ADVISORY REPORT FINDINGS AND CONCLUSIONS

To: Eric R. Shields, AICP, Planning Director
From: Tony Leavitt, Project Planner
Date: May 9, 2016
File: BARTO SETBACK VARIANCE, VAR13-00426

SIDEWALK HAZARDS

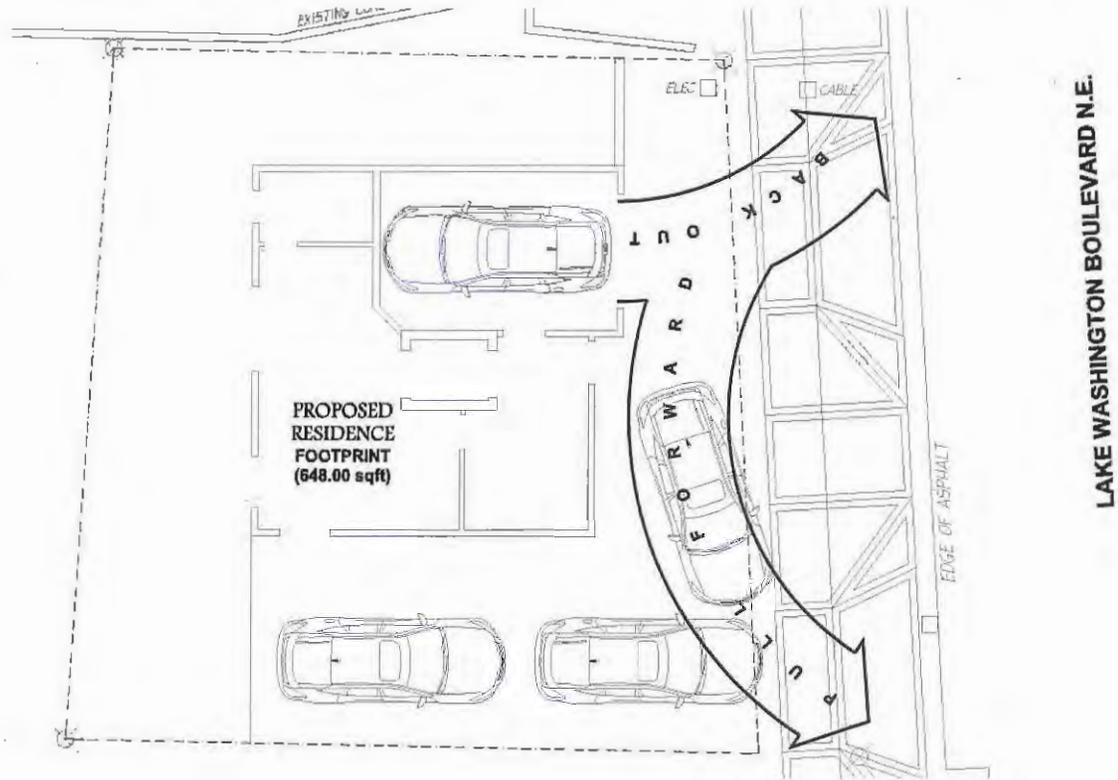
LOADING AND UNLOADING VEHICLES UTILIZE THE SIDEWALK

PEDESTRIANS AND BICYCLISTS ARE FORCED TO MOVE CLOSER TO BUSY TRAFFIC

PROPOSED PARKING PAD

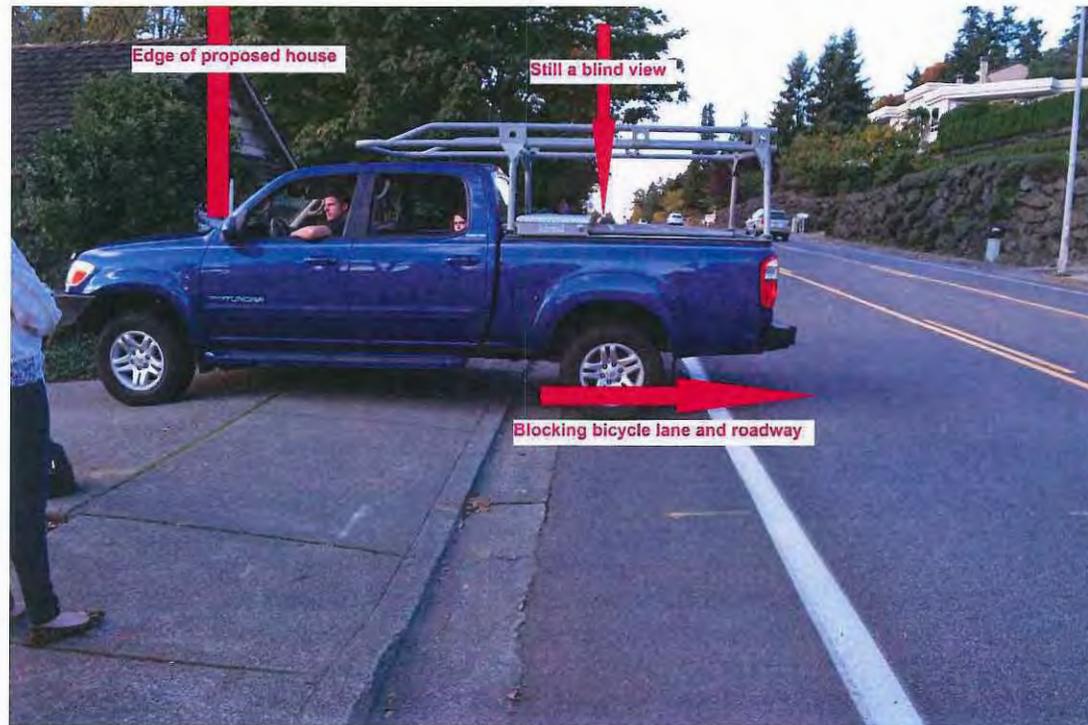
2 CARS PARKED IN THE PAD WOULD FORCE VEHICLES IN THE GARAGE AND DRIVEWAY TO BACK ONTO LWB

BACKING OUT FROM THE PARKING PAD IS DANGEROUS!

BACKING OUT FROM THE PARKING PAD IS DANGEROUS!

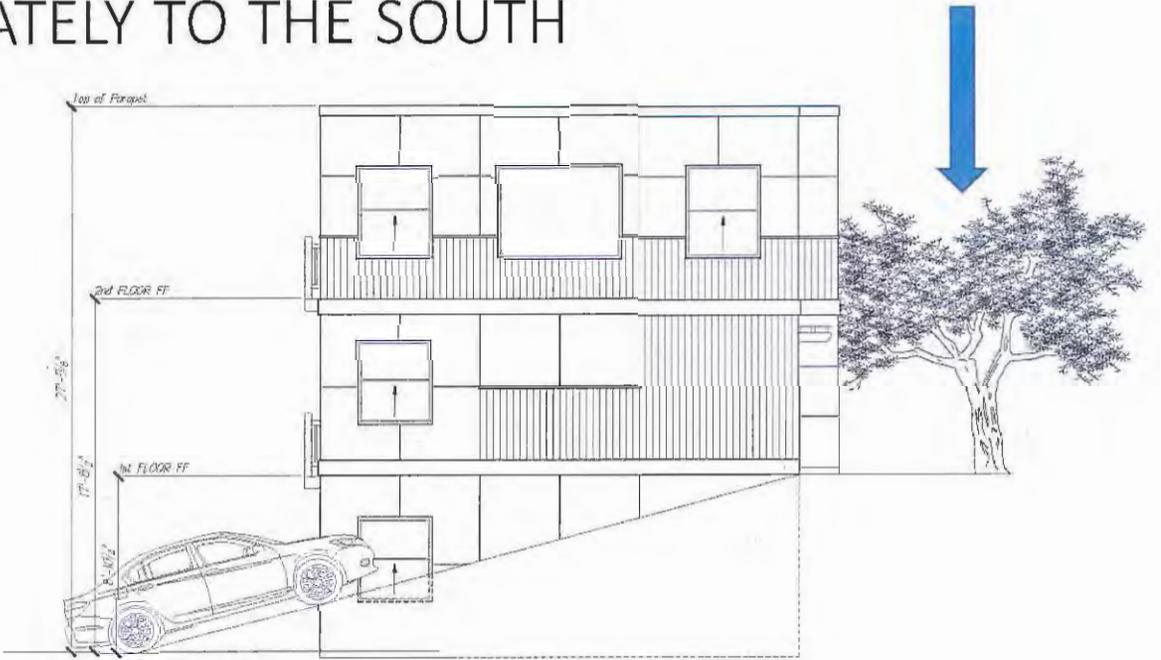
THE PROPOSED TREE PLANTED IN THE MIDDLE OF THE SIDEWALK IS AN INCREASED HAZARD TO RESIDENTS IMMEDIATELY TO THE SOUTH

PROPOSED SOUTH ELEVATION (LEFT)

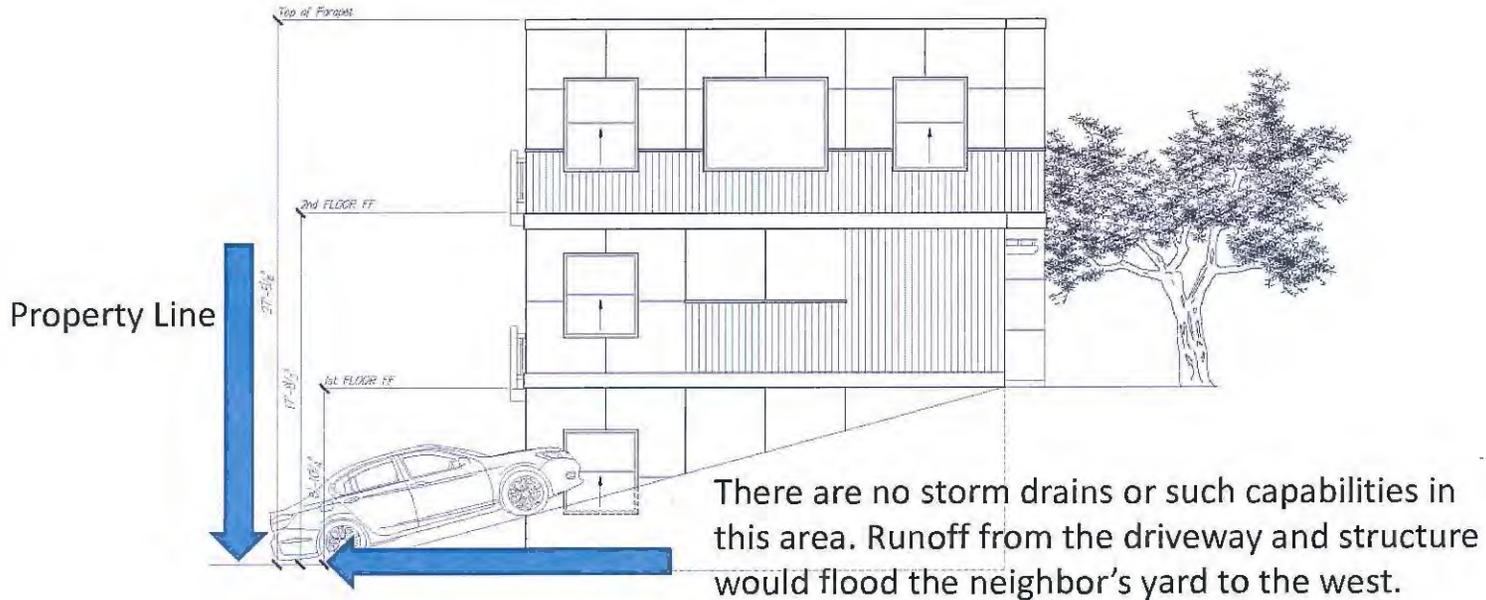
STORM DRAINS DO NOT EXIST

SIDEWALK HAZARDS

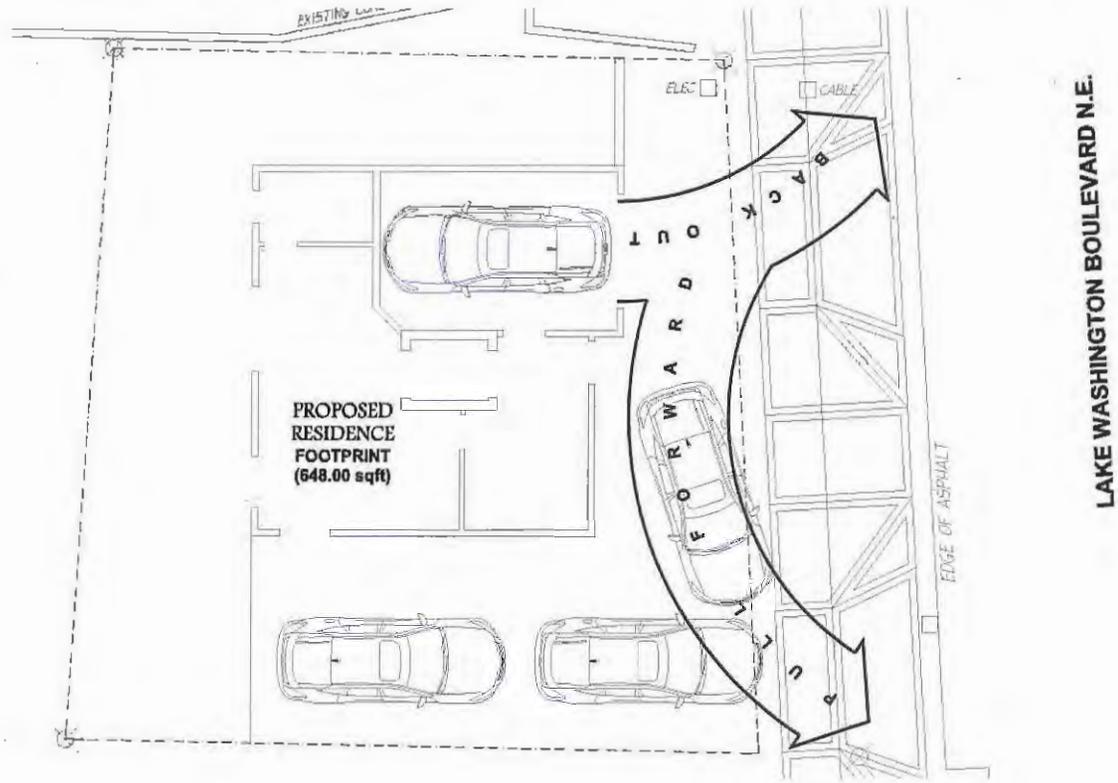
LOADING AND UNLOADING VEHICLES UTILIZE THE SIDEWALK

PEDESTRIANS AND BICYCLISTS ARE FORCED TO MOVE CLOSER TO BUSY TRAFFIC

PROPOSED PARKING PAD

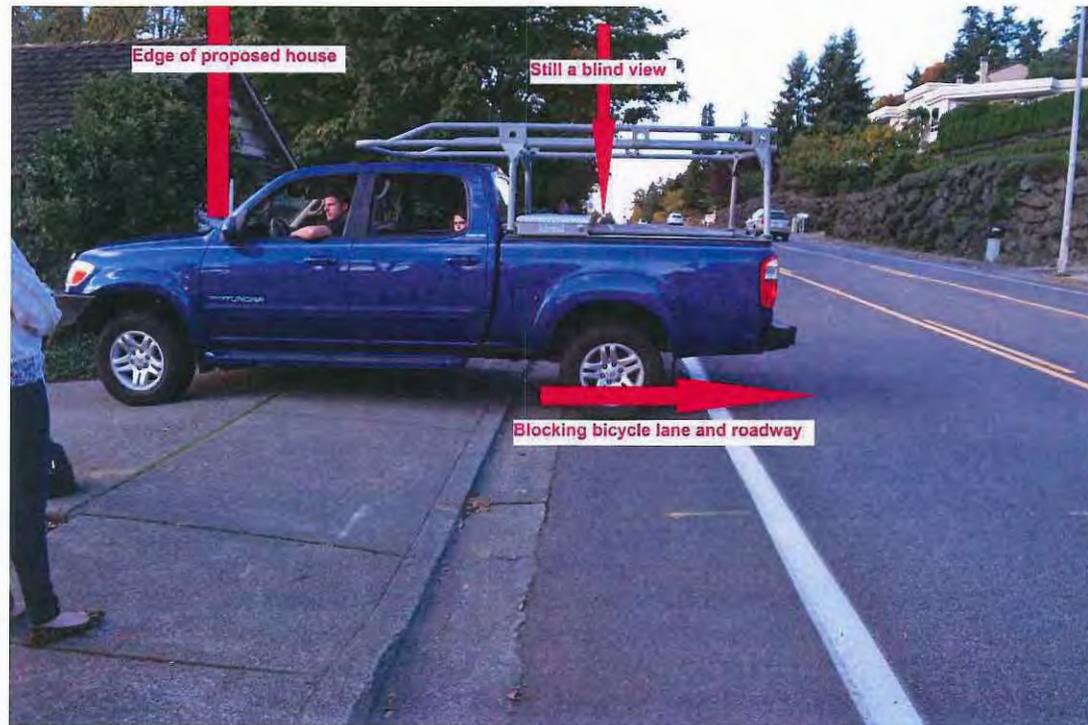
2 CARS PARKED IN THE PAD WOULD FORCE VEHICLES IN THE GARAGE AND DRIVEWAY TO BACK ONTO LWB

BACKING OUT FROM THE PARKING PAD IS DANGEROUS!

BACKING OUT FROM THE PARKING PAD IS DANGEROUS!

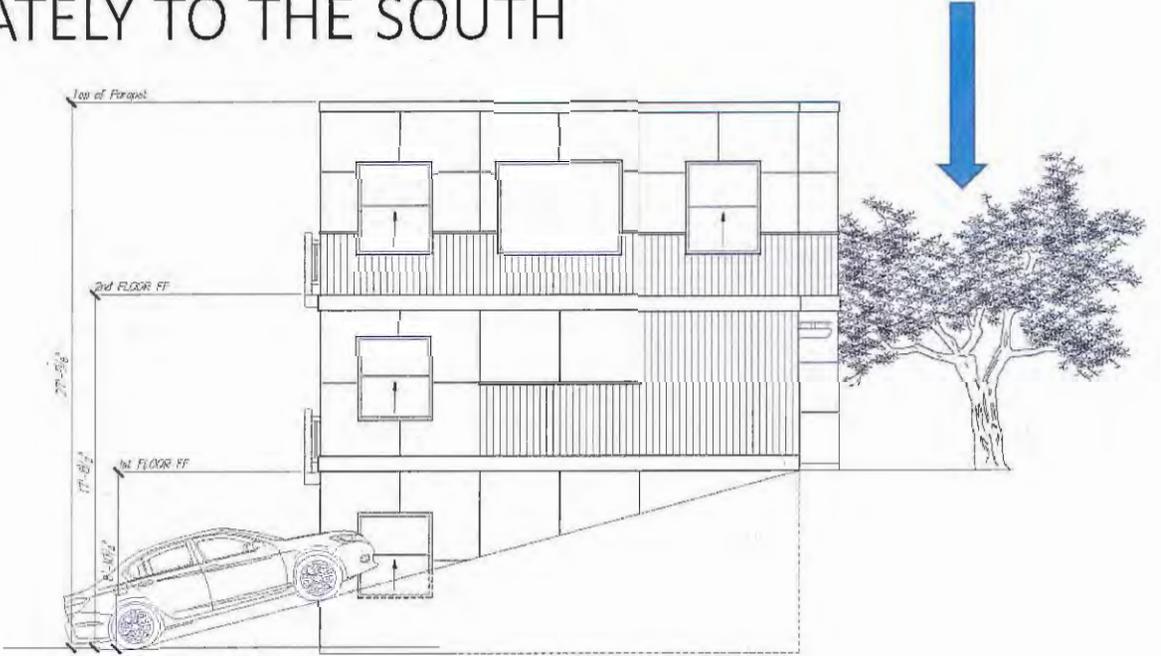
THE PROPOSED TREE PLANTED IN THE MIDDLE OF THE SIDEWALK IS AN INCREASED HAZARD TO RESIDENTS IMMEDIATELY TO THE SOUTH

PROPOSED SOUTH ELEVATION (LEFT)

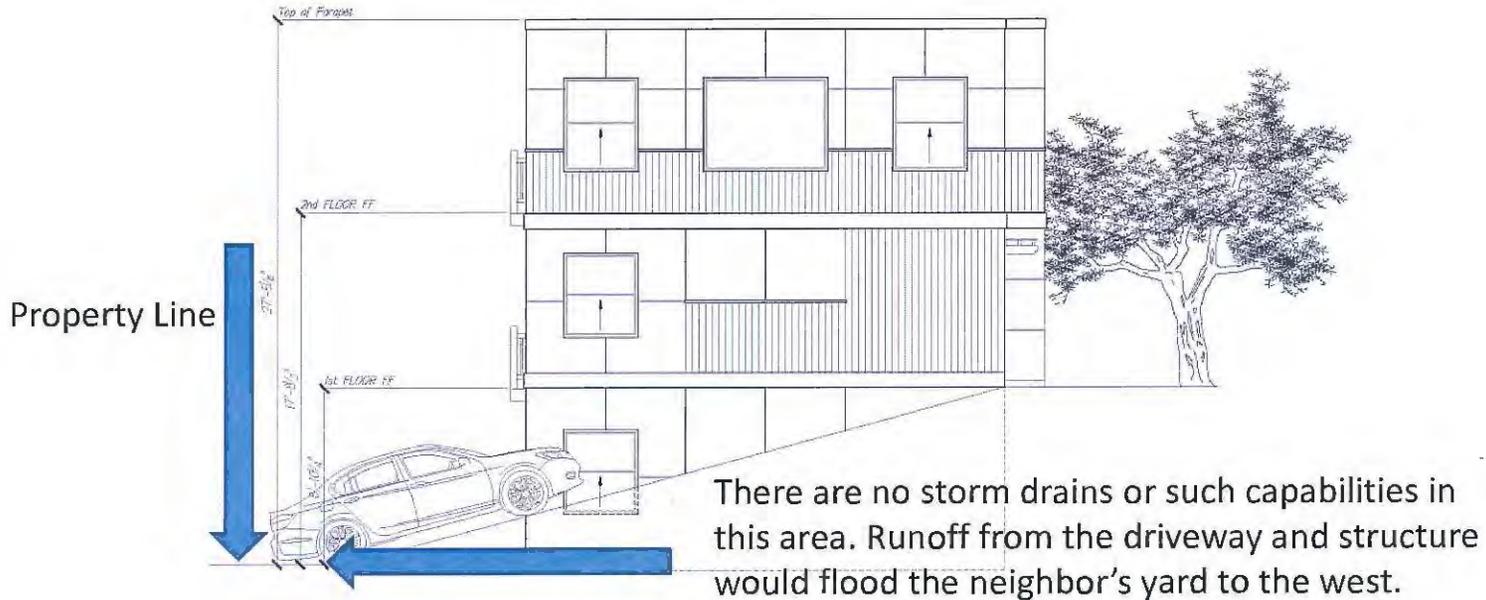
STORM DRAINS DO NOT EXIST
